DEPARTMENT OF PUBLIC WORKS

SUBJECT: Tract 6191 (previously a part of Tract 5499); PZ17-40000007; 6300 Fancher Creek Drive (APN: 313-270-97S) located west of North Armstrong Avenue and East Fancher Creek Drive Drive. The Department of Public Works offers the following comments regarding the requirements for landscaping and irrigation in the street right-of-ways, landscape easements, outlots and median islands:

Accela record number PZ17-40000007 pertains to Vesting Tentative Map of Tract No. 6191 and related Conditional Use Permit Application Accela number P18-01235 was filed by Harbour and Associates on behalf of Bonadelle Neighborhoods and pertain to approximately 11.13 net acres of property located west of the North Avenue and East Fancher Creek Drive intersection. Vesting Tentative Map of Tract No. 6191 is a request to subdivide the subject property into a 125-lot single family residential planned unit development with gated private streets. The related Conditional Use Permit Application proposes modified property development standards including reduced lot size and setbacks. The DRC with the applicant is scheduled for August 16th at 1:30 p.m.

EXHIBIT NO. 1

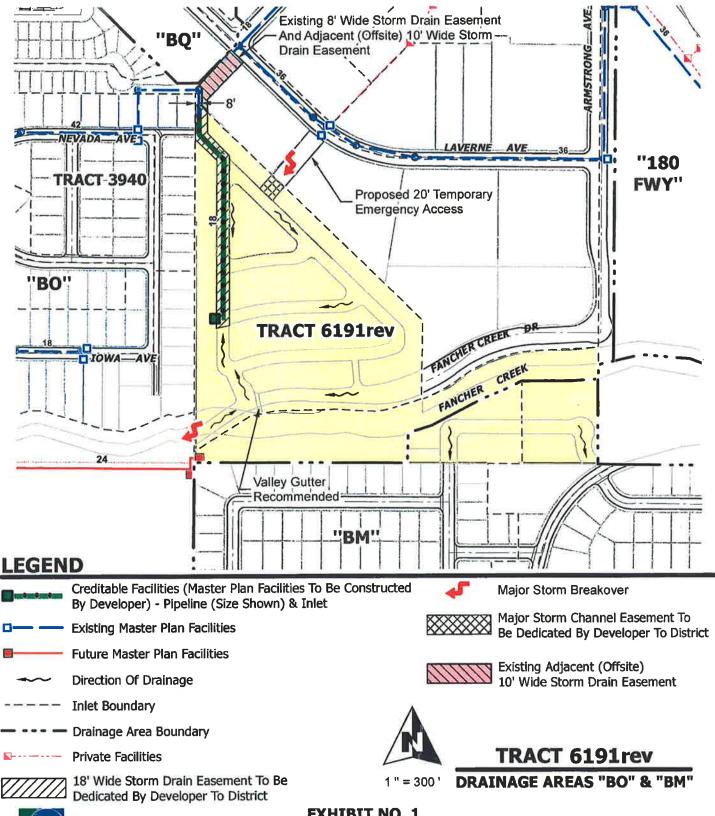
Appro	oval of this d	evelopment snall be conditioned upon compliance with these District Requirements.	
1.	2	. Drainage from the site shall	
	_ <u>X</u> _ b	. Grading and drainage patterns shall be as identified on Exhibit No. 1	
	c	The grading and drainage patterns shown on the site plan conform to the adopted Storm Drainage and Flood Control Master Plan.	N

2.	located v	posed development shall construct and/or dedicate Storm Drainage and Flood Control Master Plan facilities within the development or necessitated by any off-site improvements required by the approving agency:	
	<u>X</u>	Developer shall construct facilities as shown on Exhibit No. 1 as MASTER PLAN FACILITIES TO BE CONSTRUCTED BY DEVELOPER.	Z
	_	None required.	D
